**Mixer ladder bolts may have been over-torqued resulting in the need for new hardware**

**Date:** April 13, 2023  
**Bulletin Name:** MXR-TSB-032  
**Model:** Bridgemaster Mixer (93) and Standard Mixer (90)  
**Model Year:** 2022

Figure 1

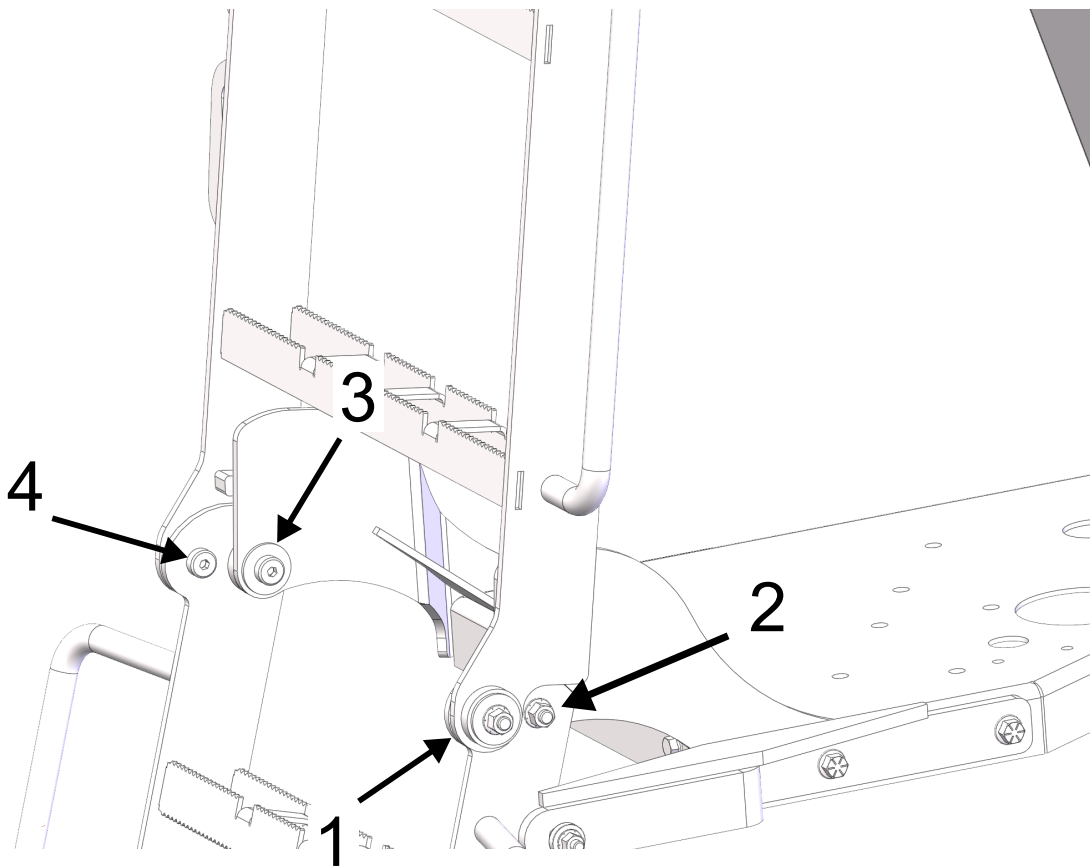
McNeilus Truck and Manufacturing identified an issue with over-torqued bolts on the lower ladder platform. The bolts used to secure the lower ladders to the lower ladder platform were over-torqued causing the bolts to fail. New hardware needs to be installed in place of the over-torqued bolts.

2. Unfold the lower ladder to the down position.
3. Use a wrench to remove the existing bolts, washers, and nuts that secure the assembly at Item 1 in Figure 1. Discard the existing hardware.

4. Use a bolt, nut, and washer to secure the assembly joint at Item 1 in Figure 1. Use a torque wrench to torque the nut to 33 ft.-lbs.
5. Once torqued to 33 ft.-lbs., back the nut off by 1/2 turn.

6. Repeat steps 3 - 5 for the fasteners securing the assembly at Items 2, 3, and 4.
7. The procedure is complete. Remove your company's Lockout/Tagout procedure. If your company does not have a Lockout/Tagout procedure, follow OSHA 1910.147 and 1910.146 Confined Space as appropriate. Chock wheels and engage the service brake. Return the truck to service.
